A585 Windy Harbour to Skippool Improvement Scheme

7.11 Environmental Statement Changes and Corrections Document

Environmental Statement Changes and Corrections Document

Version	Date	Status of Version
Rev 0	May 2019	Deadline 2 Submission
Rev 1	July 2019	Deadline 4 Submission

APPENDIX C – Updated Figure 9.10 Photomontage at viewpoint location 2, view from residential properties on Breck Road, Photomontage at Viewpoint Location 9, view from Footpath 5-11-FP 2 at Junction with A585 Garstang New Road and Photomontage at viewpoint location 10, view from the B5260 Lodge Lane

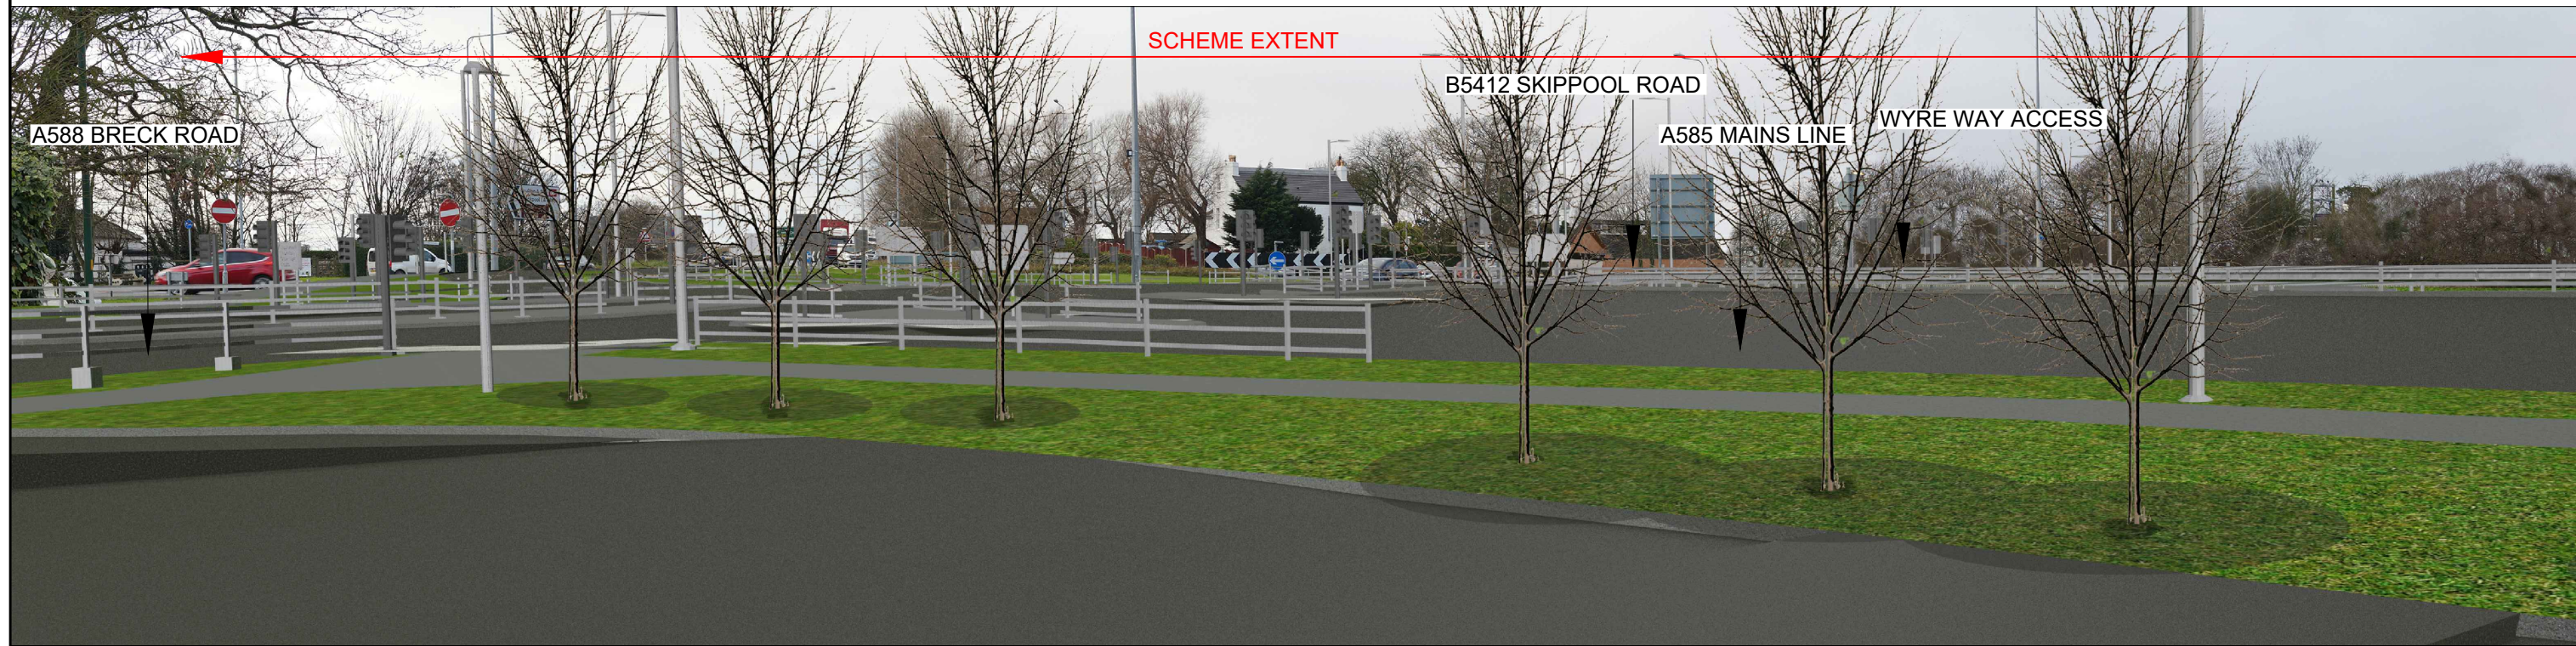
Document Reference Number	Document Name	Amendment Required	Reason									
6.9	ES Chapter 9: Landscape	Update to Figure 9.10, Photomontage at viewpoint location 2, view from residential properties on Breck Road provided within Appendix C.	As a result of updates to the Flood Risk Assessment associated with the dwarf wall.									
6.9	ES Chapter 9: Landscape	Update to Figure 9.10, Photomontage at viewpoint location 10, view from the B5260 Lodge Lane provided within Appendix C.	Updated to show the 3m high acoustic barrier to the north of the cutting.									
6.9	ES Chapter 9: Landscape	Update to Figure 9.10, Photomontage at viewpoint location 9, view from the A585 Garstang New Road provided within Appendix C.	Updated to show the additional linear planting adjacent to Grange Footbridge, as a result of request from Fylde Borough Council (document reference TR010035/APP/7.9).									
6.9	ES Chapter 9: Landscape	Update to Table 9-16

Drawing Title
ENVIRONMENTAL STATEMENT REGULATION 5(2)(a) NOISE AND VIBRATION: NOISE MONITORING LOCATIONS WITHIN STUDY AREA

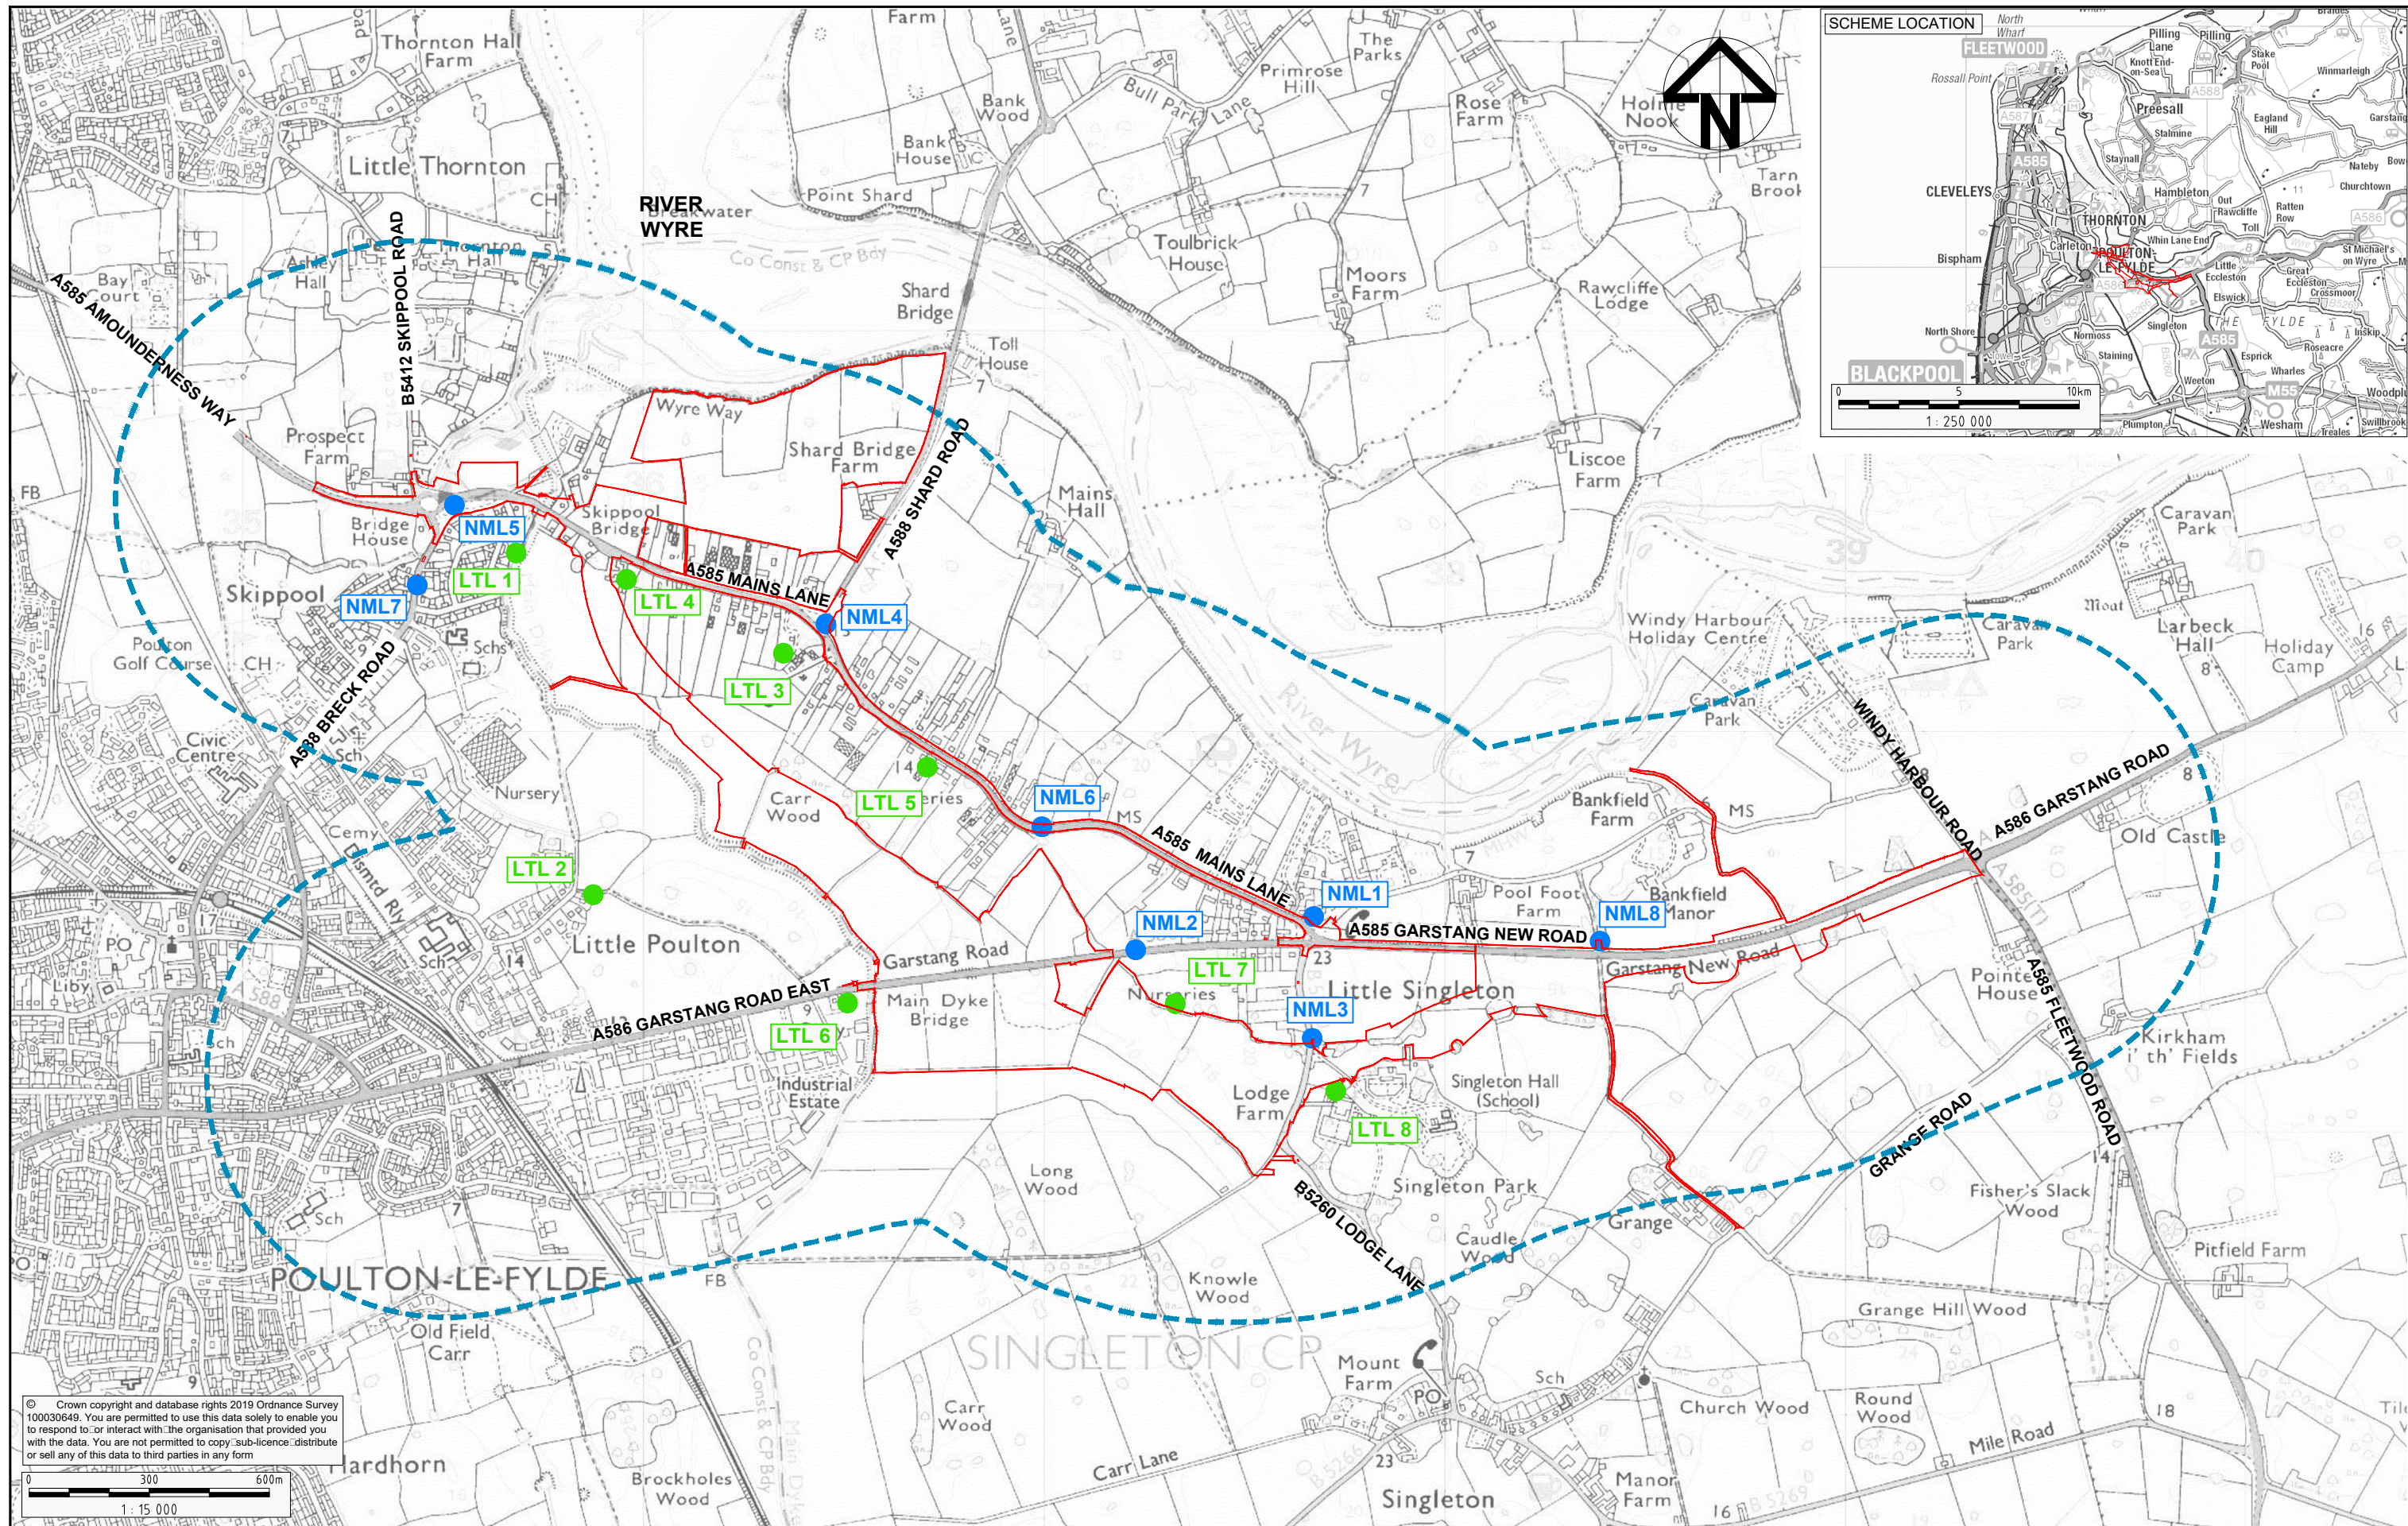
6.11	ES Chapter 11: Noise and Vibration	Update to Figure 11.1: Noise and Vibration – Noise Monitoring within the Study Area presented at Appendix D to show the locations of the eight attended noise surveys.	Requested by the Inspector within the first round of written questions (document reference
